Before the Independent Hearing Panel  
Appointed by the Timaru District Council

**Liz White – Hearing F - Interim reply**

**Light and Noise**

6 June 2025

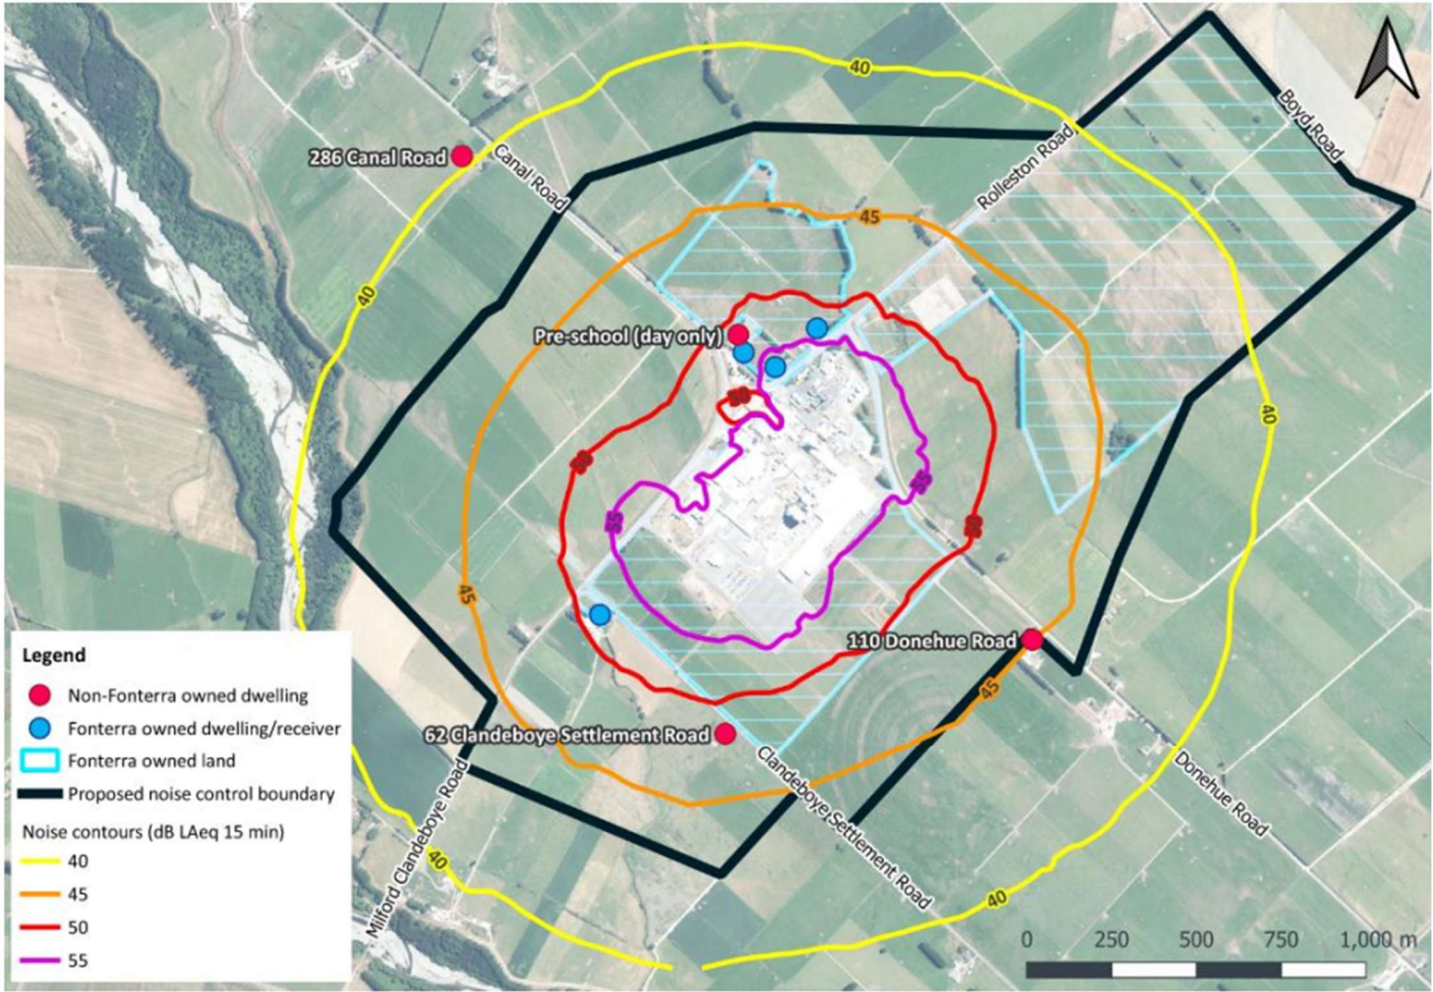
<p>It can be seen from this summary data that the critical temperature plus 2.2 degrees C is not, in general, above the 2 degrees C standard of PER-3. Only 1 species in Table 4.5 (Witloof chicory) resulted in 2.2° C above the ‘critical temperature’ exceeding the 2 degree threshold of PER-3. Thus, I do not support the submitter’s request to amend PER-3 as it appears this would result in frost fans commencing operations at colder temperatures than that specified in PER-3 which I do not believe is what the submitter intended.</p> <p><u>Bird Scaring Devices - Hours of Operation</u></p> <p>The submitter’s expert seeks NOISE-R5 PER-4 be amended so that hours of operation for audible bird scaring devices may commence half an hour before sunrise instead of the currently proposed 7am. Note, the adjustment for the evening has already reflected the submitter’s request to enable bird scaring devices to operate until half an hour after sunset. I have given consideration to the improved protection afforded by the ‘half an hour before sunrise’ start time, however owing to potential sleep disruption, I do not support early operation of bird scaring devices as requested. During the longest day period during December, the change sought would allow bird</p>	Summary statistic	Data As Published	Data as published +2.2 degrees	Median	-0.9 degrees	1.3 degrees	Average	-1.3 degrees	0.9 degrees	Minimum	-15.7 degrees	-13.5 degrees	Maximum	-0.1 degrees	2.1 degrees
Summary statistic	Data As Published	Data as published +2.2 degrees															
Median	-0.9 degrees	1.3 degrees															
Average	-1.3 degrees	0.9 degrees															
Minimum	-15.7 degrees	-13.5 degrees															
Maximum	-0.1 degrees	2.1 degrees
